SUBJECT: COMANCHE PEAK NUCLEAR POWER PLANT, UNITS 3 AND 4
DOCKET NUMBERS 52-034 AND 52-035
SUPPLEMENTAL RESPONSES TO REQUEST FOR ADDITIONAL INFORMATION
NO. 4207 (SECTION 12.3-12.4) AND NO. 4208 (SECTION 12.5)

Comanche Peak, Units 3 and 4

SUBJECT: COMANCHE PEAK NUCLEAR POWER PLANT, UNITS 3 AND 4
DOCKET NUMBERS 52-034 AND 52-035
SUPPLEMENTAL RESPONSES TO REQUEST FOR ADDITIONAL INFORMATION
NO. 4294 (SECTION 3.7) AND NO. 4542 (SECTION 3.8)

SUBJECT: COMANCHE PEAK NUCLEAR POWER PLANT, UNITS 3 AND 4
DOCKET NUMBERS 52-034 AND 52-035
RESPONSES TO REQUEST FOR ADDITIONAL INFORMATION NO. 5317
(SECTION 3.7.1), NO. 5411 (SECTION 6.4), AND NO. 5465 (SECTION 2.3.1)

Figure 1 – Site Response Soil Column Analysis Results Showing Ground Surface Acceleration Response Spectra for Four Soil Profiles due to Rock Outcrop Motion Applied at Foundation Level

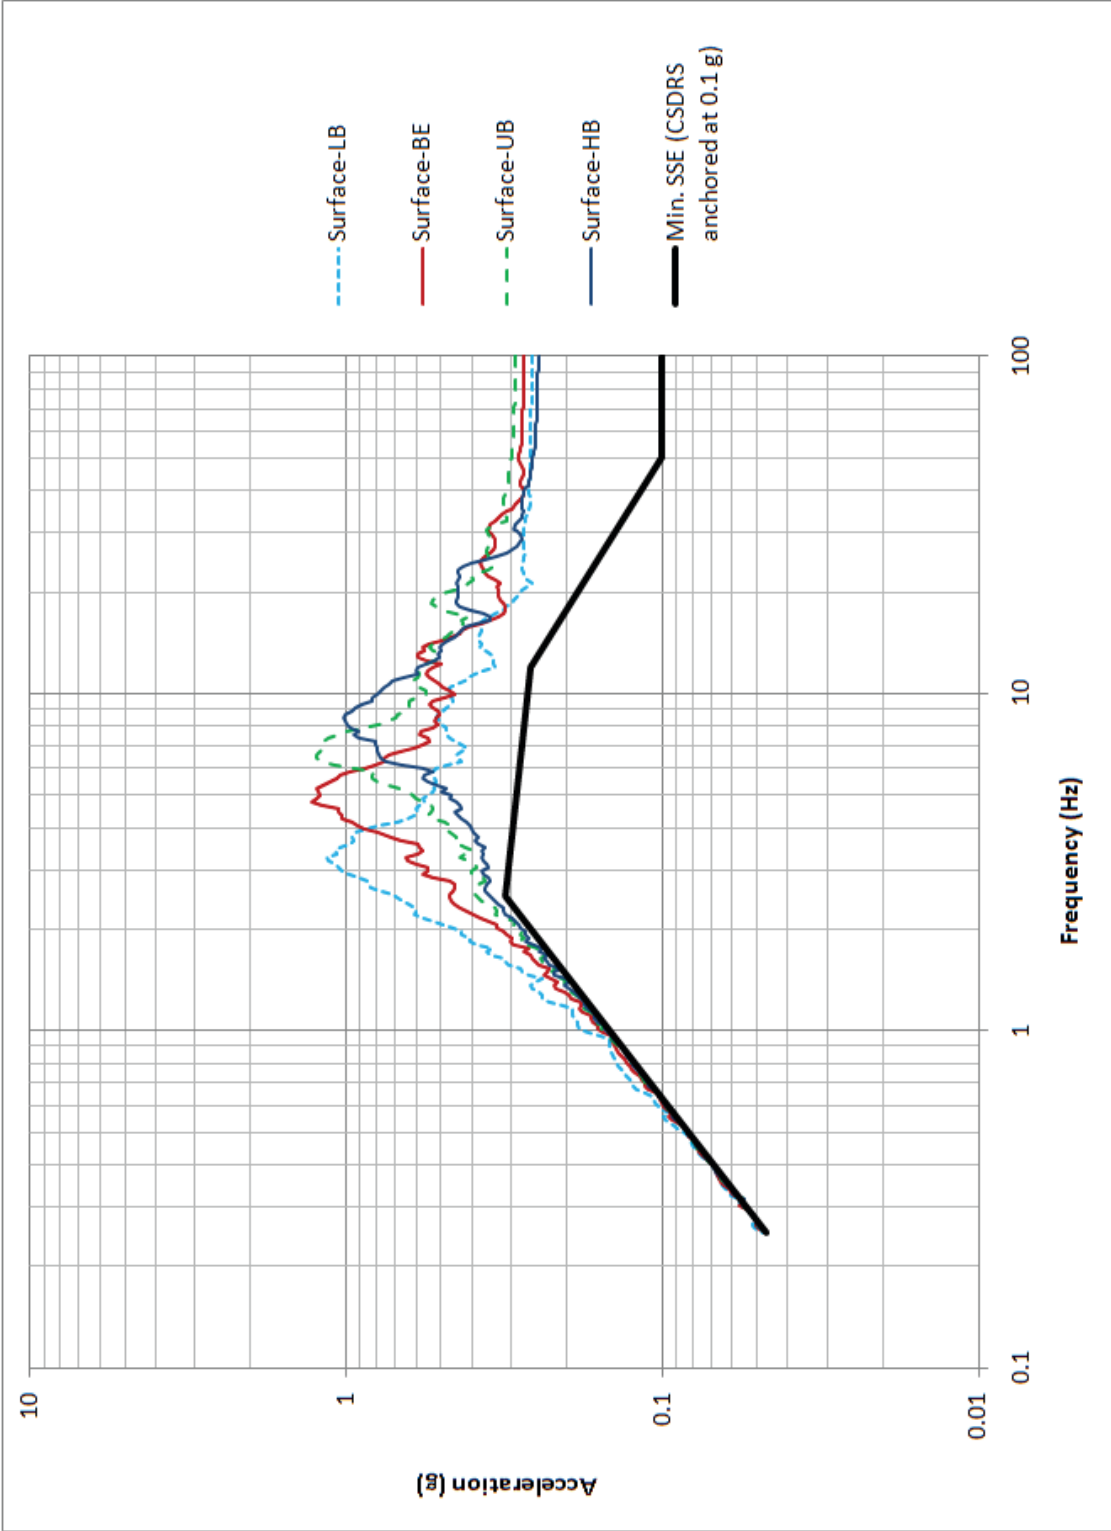
In response to RAI 3.7.1-3 Luminant has stated that the development of foundation input response spectra (FIRS) 1, FIRS 2, and FIRS 3 is consistent with the recommendations of NEI (2009) *Consistent Site-Response/Soil-Structure Interaction Analysis and Evaluation* for embedded structures that are analyzed as surface structures. To date, the soil-structure interaction (SSI) analysis performed in support of the US-APWR Standard Plant has treated embedded structures as surface structures. In contrast, in the SSI analysis of the CPNPP structures, embedded structures are analyzed as embedded structures, not surface structures.

Consequently, FIRS 1, FIRS 2, and FIRS 3 that were developed for treating embedded structures as surface structures will not generally be the same FIRS for analyzing embedded structures as embedded structures. Section 3.2.3 of NEI gives a multi-step process for developing FIRS to be used when analyzing embedded structures as embedded structures. Provide justification for using FIRS 1, FIRS 2, and FIRS 3 as the basis of comparison for determining the proper seismic input to the CPNPP structures and describe how the current approach does or does not meet the guidelines of DC/COL Interim Staff Guidance-017 (which adopts the methodology of NEI [2009]).

Figure 1 shows the horizontal ground motion acceleration response spectra (ARS) calculated in the site response analyses. The figure shows the 0.1 g CSDRS and surface ARS calculated for each of the four soil cases: lower bound (LB), best-estimate (BE), upper bound (UB) and high bound (HB) as indicated. The 0.1 g CDSRS motion was input as outcrop motion at the foundation level at top of limestone. The resulting ground surface ARS are significantly higher than the outcrop motions input at rock level.
